Hyattsville Accessibility Transition Plan

St. Matthew's Church - Ward 4 Voting Location - Hyattsville Transition Plan

Address: 5601 36th Street

St. Matthews Church (Voting Location Ward 4)

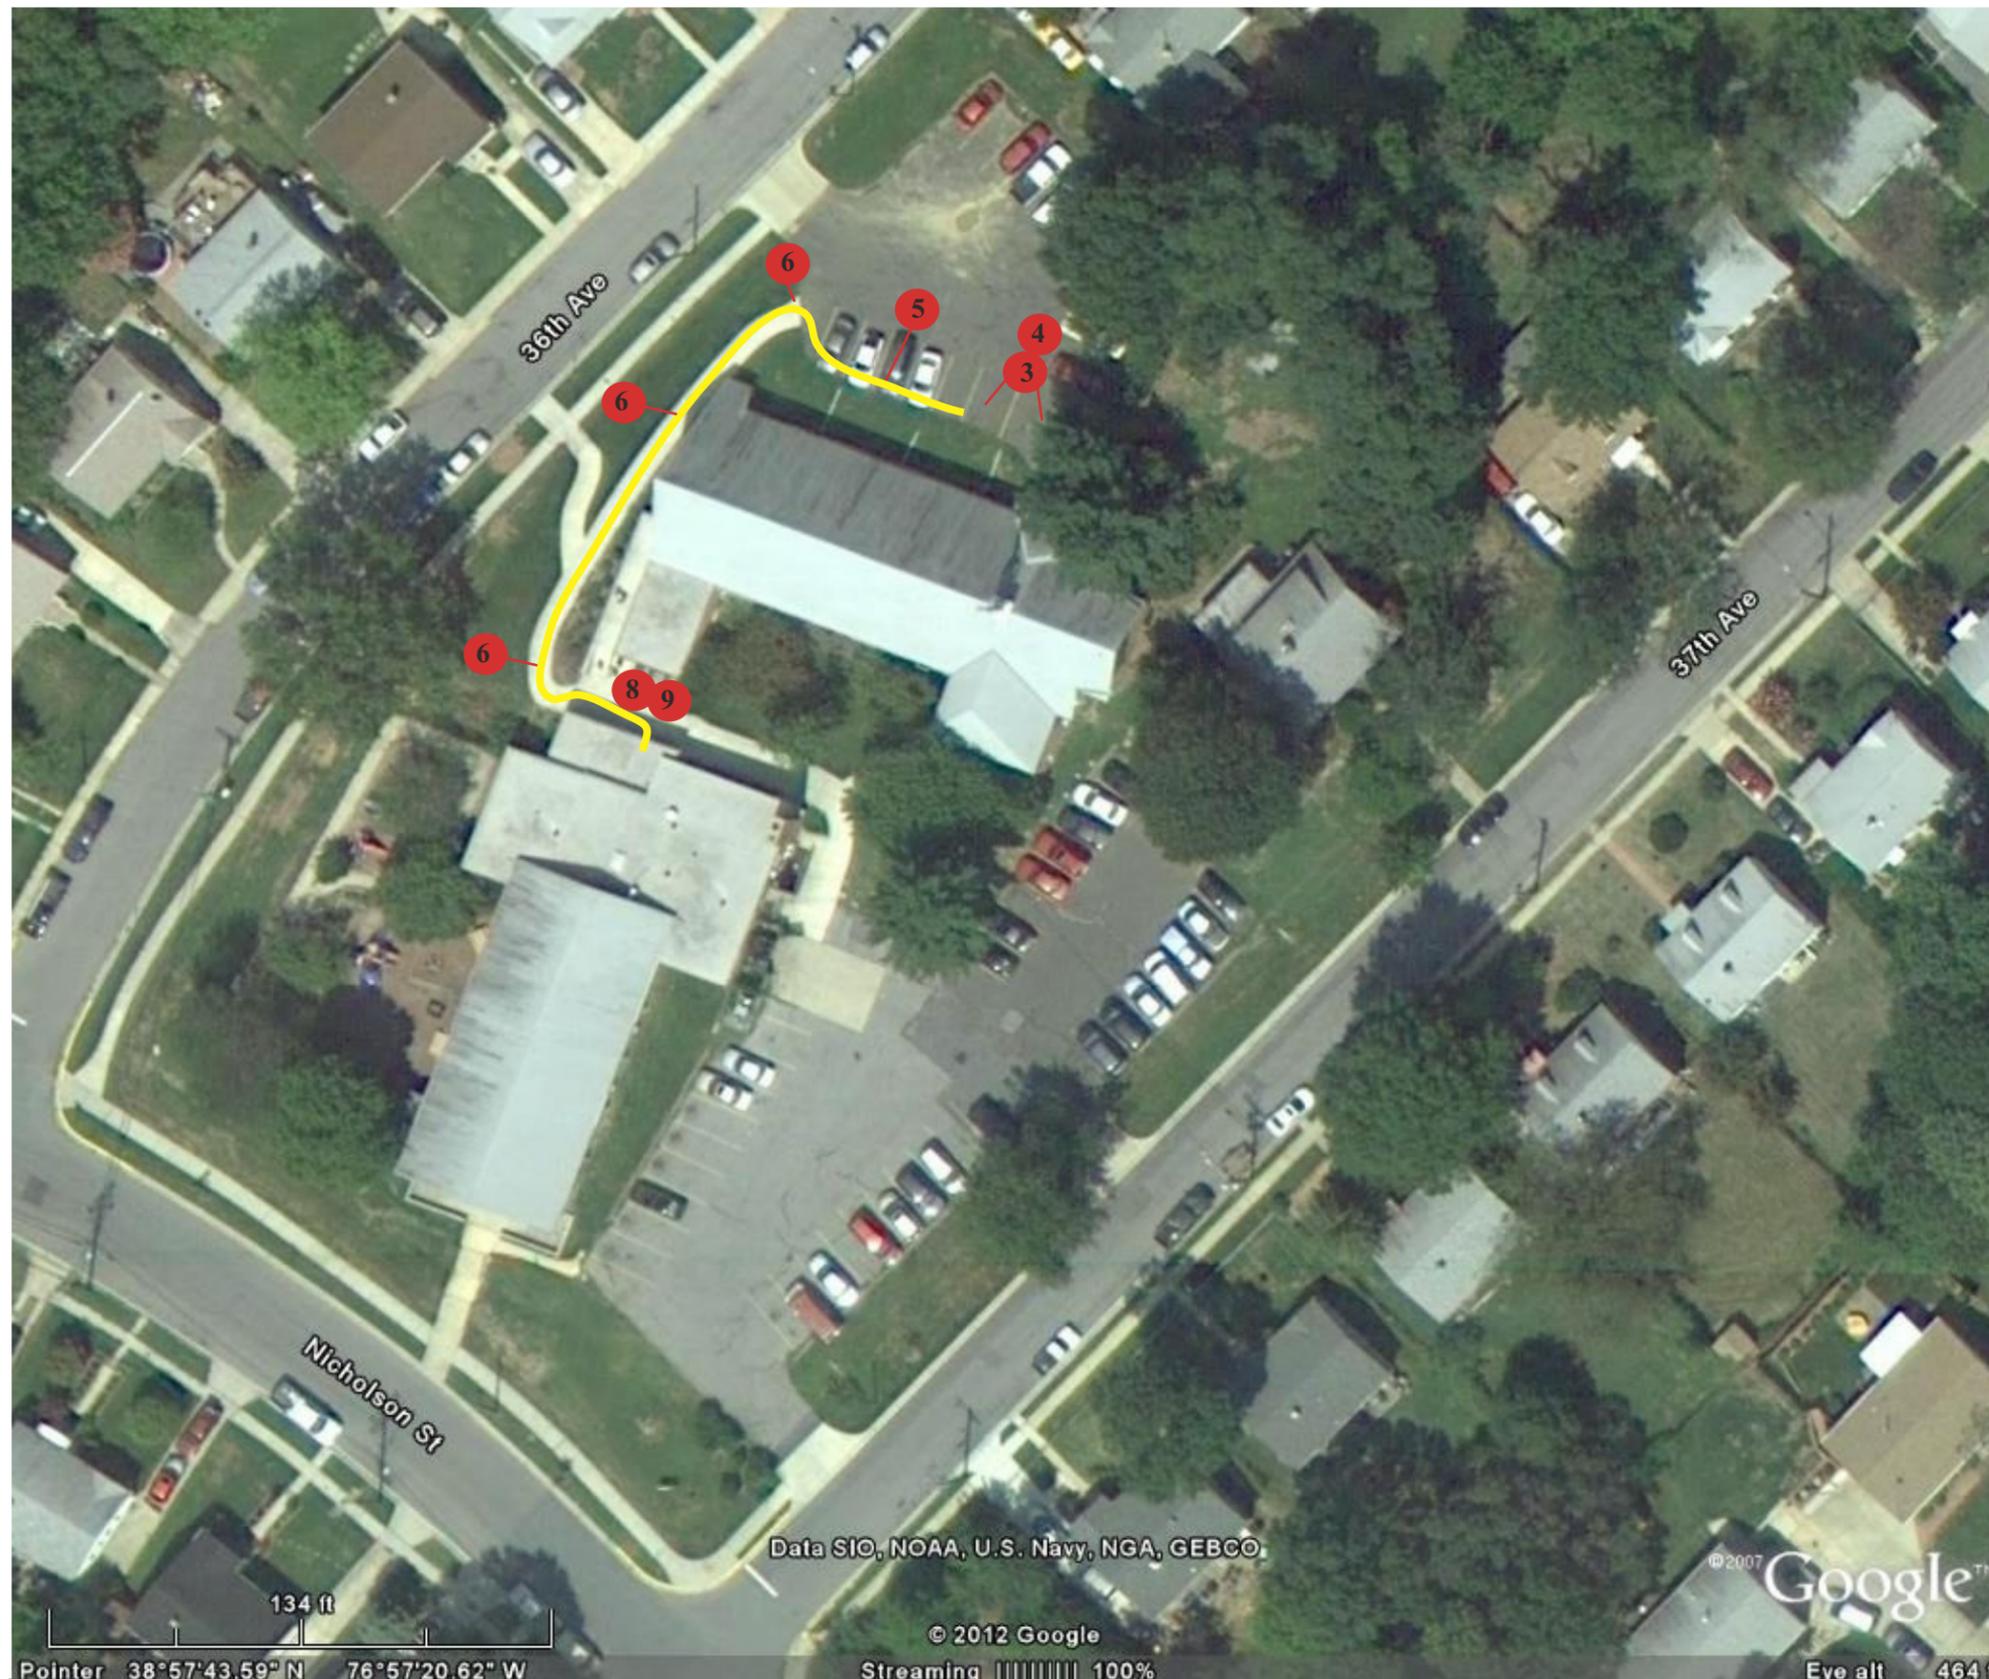
2010 Standards Citation	Description/Issue/Requirement	Non-Complying Item	Photos	Proposed Solution	Suggested Priority	Projected Cost Hyattsville	Projected Date	Action and Date
1								
2	Exterior Accessible Route from Front Parking Lot located on 36th Avenue to Lobby Entry Door :							
3	*208.2.4, At least one van accessible parking space must be provided for every 6 accessible parking spaces.	There are an approximate total of 48 spaces in the two parking lots (one of the lots is not fully striped so amount is estimated) . Two (2) accessible spaces are required and provided. Therefore, at least one(1) must be van accessible. However, no van spaces are provided.	6849	Restripe one of the existing handicap spaces and one of the standard spaces to provide for a van accessible space. Create an eight (8) foot wide van accessible space with an eight (8) foot wide access aisle. Provide new van accessible signage.	1	\$1,525

4	208, 502.4 Parking spaces and access aisle cannot slope more than 2% in any direction.	A significant portion of the accessible parking spaces and access aisles in the front lot have a slope of 8.1%.	6845, 6846	Install new 2" asphalt topping over two (2) accessible spaces in the parking lot with a maximum slope and cross slope of 2%.	1	\$1,440		
5	206.1, 405.8 Accessible route cannot have a cross slope that is more than 2%.	A significant portion of the accessible route from the accessible parking spaces through the front parking lot has a cross slope of 7.1%.	6837, 6838	Provide an accessible route from the accessible parking spaces to the sidewalk. Provide new asphalt topping 5' wide at the top of the existing parking spaces with a slope of no more than 5% and a cross slope no more than 2% . Restripe 5 standard spaces and provide wheel stops.	1	\$3,975		
6	206.1, 403.3 Accessible route cannot slope more than 8.33% and cannot slope more than 5% without having ramp features.	At the sidewalk leading from the parking lot to the lobby entry door, the slope is between 6.1% and 7.2% at several portions of the sidewalk.	6827, 6828, 6831, 6832, 6835, 6836	Regrade and reconstruct portions of the concrete sidewalk to the lobby to have a maximum slope of 5%.	1	\$2,640

7	Exterior Accessible Route from Sidewalk to Front Door:							
8	207.1, 406.1 Slope of curb ramp cannot exceed 8.33%.	The curb ramp at the entry porch has a slope of 17.1%.	7012, 7013	Rebuild ramp as a Type B curb ramp with new landing parallel to existing door stoop. Remove existing curb ramp.	1	\$4,100		
9	206.5, 404.2.4.4 Maneuvering space at the door cannot slope more than 2%.	The maneuvering space outside the entry door has a slope of 3.0%.	2784, 2785	Rebuild concrete stoop at entry door to have a slope and cross slope no more than 2%.	1	\$3,600		
10	Lobby and Vestibule
